IMPORTANT SAFETY RECALL

Re: Safety Recall - Smart-Steer 2.0 Self-Steer Axle

Recall 21E-019

Subject: SMART-STEER 2.0 Bolt-On Steer Arm Reinforcement Welds

DETAIL A
SCALE 1 : 4

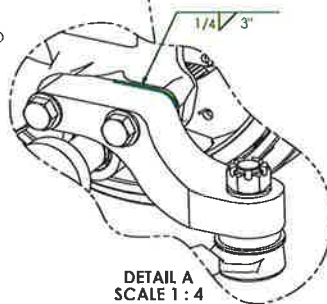
NOTE:
TURN KNUCKLE AT FULL TURN TO
GAIN ACCESS TO STEER ARM
AND WELD

1. Visually inspect steer arm bolts and washers for mechanical tightness and replace if necessary.
2. Ensure the steer arm bolts are torqued to 400 Ft. Lbs.
3. Place welds as shown on page three of this bulletin. If you would like a copy of engineering drawing 750049, please contact one of the service technicians listed below.

DETAIL C
SCALE 1 : 4

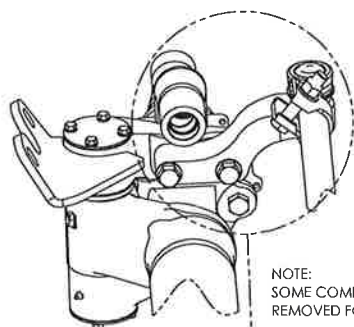
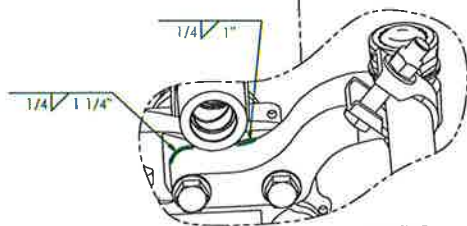
NOTE:
SOME COMPONENTS WERE
REMOVED FOR CLARITY.

DETAIL B
SCALE 1 : 4

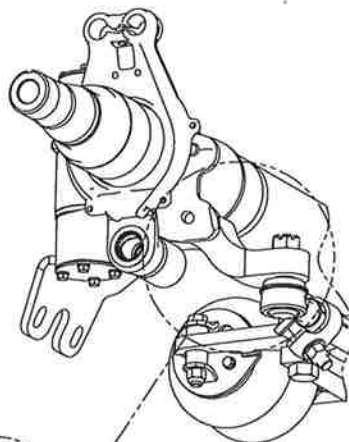
NOTE:
SOME COMPONENTS WERE
REMOVED FOR CLARITY.
